ADDENDUM NO. 4

TO: Contract Documents for Construction of Central Avenue Flood Control Improvements - A FEMA Funded Project - Oracle Project No. 1002549

This Addendum No. 4 modifies the base bid schedule and corrects and clarifies the plans and specifications. Changes to project plans on attached sheets are shown clouded.

ACCESS ROAD TYPICAL SECTION (TEMPORARY)
N.T.S.

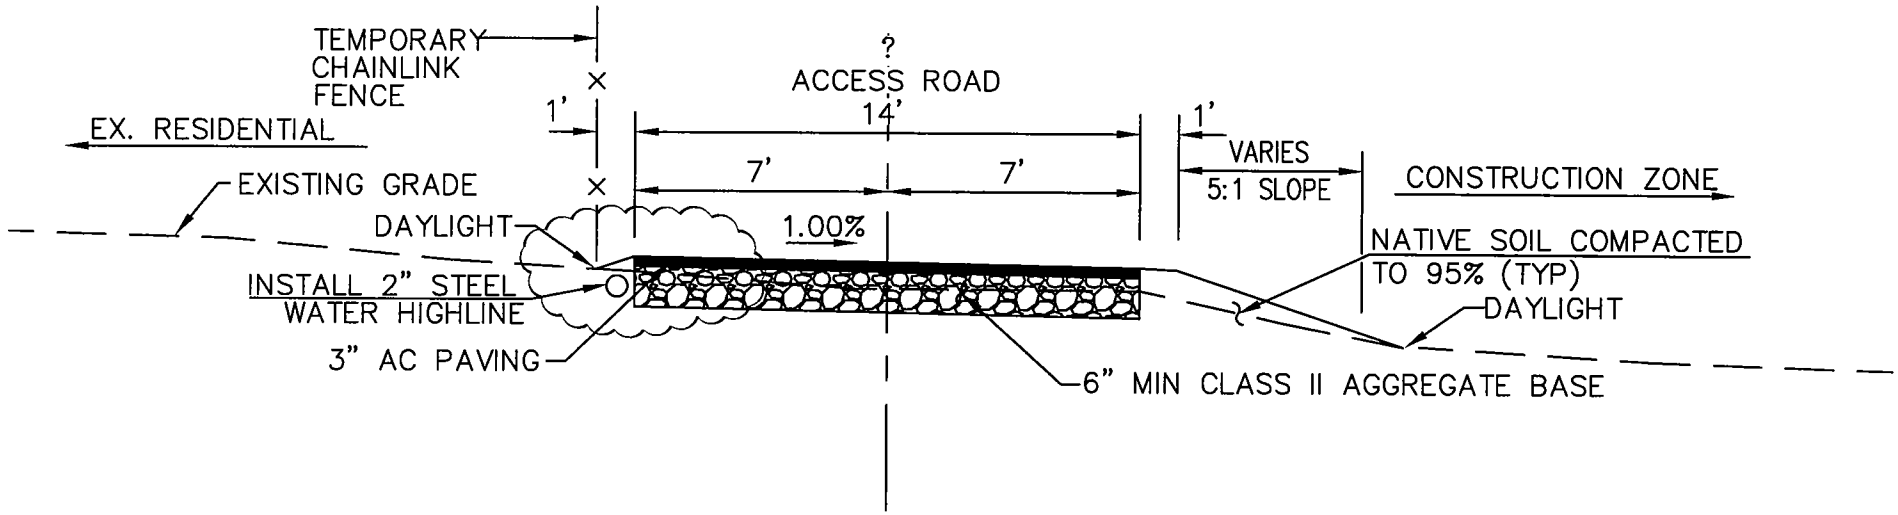
13. On sheet 9 of the project plans, replace the temporary access road typical section with the attached typical section entitled, "ACCESS ROAD TYPICAL SECTION (TEMPORARY) [ADDENDUM NO. 4]".

UPDATED ACCESS ROAD PLAN TO REMOVE DAYLIGHT LINE OUTSIDE TCE AND MODIFY SECTION TO REFLECT DAYLIGHT LINE ON SHEET 9
